DART AEROSPACE LTD		Work Order:	26221
Description: Crosstube Assembly (205/212 High Aft)		Part Number:	D212-664-241
Inspection Dwg: D212-664-241 Rev: D		Page 2 of 2

DRAWING NO. D212-664-241	TITLE CROSSTUBE ASSY (205/212 HI AFT)	REV. D	DART AEROSPACE LTD ENGINEERING ORDER		D.E.O. NO. D212-664-241-D-1	SHEET NO. SHEET 1 OF 2	SCALE NTS
DRAWN	CHECKED	MFG. APPR.	APPROVED	DE APPR.			
DATE 11.04.07	DATE 11.04.11	DATE 11.04.12	DATE 11/04/12	DATE 11.04.12

DRAWING NO. D212-664-241	TITLE CROSSTUBE ASS'Y (205/212 HI AFT)	REV. D	DART AEROSPACE LTD ENGINEERING ORDER		D.E.O. NO. D212-664-241-D-2	SHEET NO. SHEET 1 OF 1	SCALE NTS
DRAWN <i>92</i>	CHECKED <i>ASS</i>	MFG. APPR. <i>DS</i>	APPROVED <i>MP</i>		DE APPR. <i>#4</i>		
DATE 11.07.15	DATE 11.07.20	DATE 11.07.21	DATE 11/27/21		DATE 11.07.21

**D212-664-241/-241B
ASSEMBLY DETAIL**

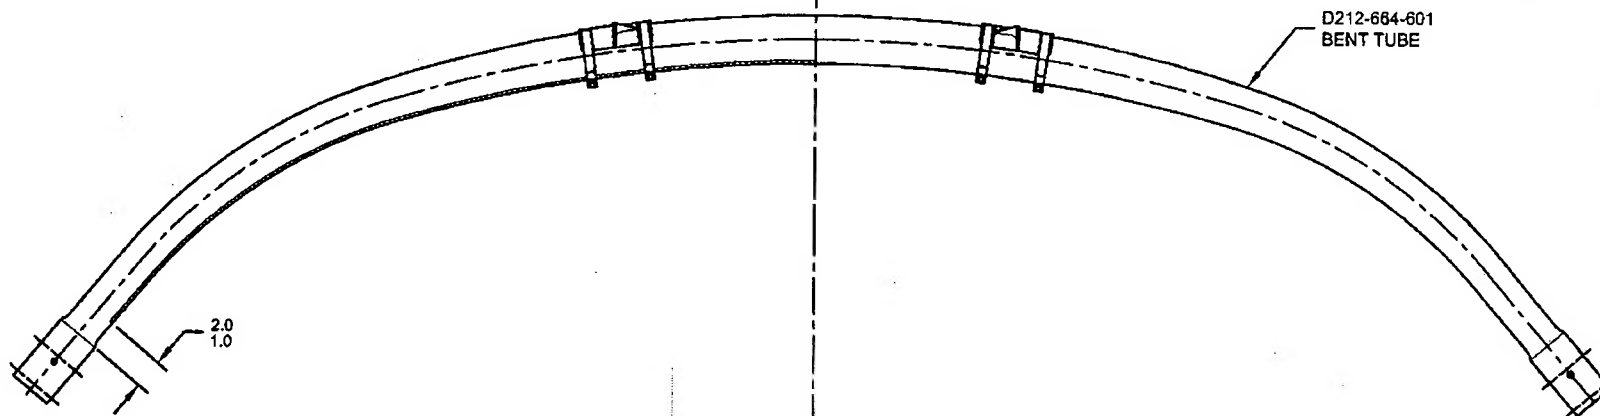
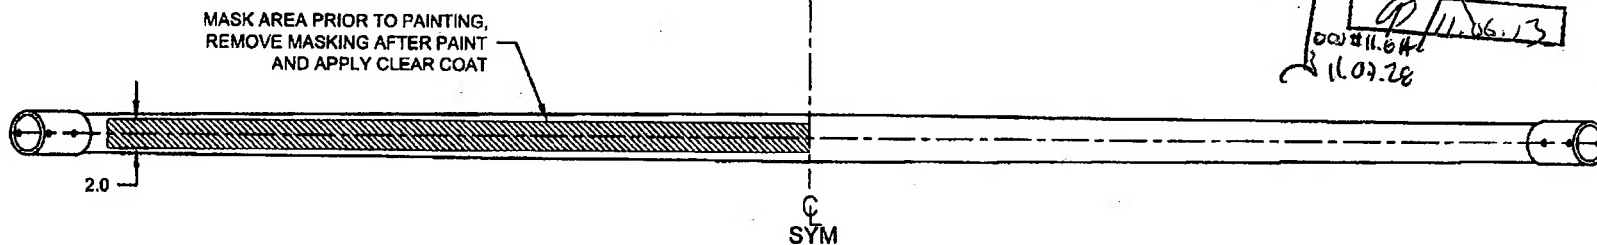
PURPOSE:

ADD AN INSPECTION WINDOW TO UNDERSIDE OF CROSSTUBE.

NOTES 2 OF SHEET 1 IS AMENDED AS FOLLOWS:

- 2) FINISH: CHEMICAL CONVERSION COAT PER DART QSI 005 4.1
PRIME INSIDE AND OUTSIDE PER DART QSI 005 4.2
MASK UNDERSIDE OF CROSSTUBE AS SHOWN (HATCHED AREA) AND
PAINT OUTSIDE PER DART QSI 005 4.2
REMOVE MASKING AND APPLY CLEAR COAT

- 2) FINISH: CHEMICAL CONVERSION COAT PER DART QSI 005 4.1
PRIME INSIDE AND OUTSIDE PER DART QSI 005 4.2
PAINT OUTSIDE PER DART QSI 005 4.2
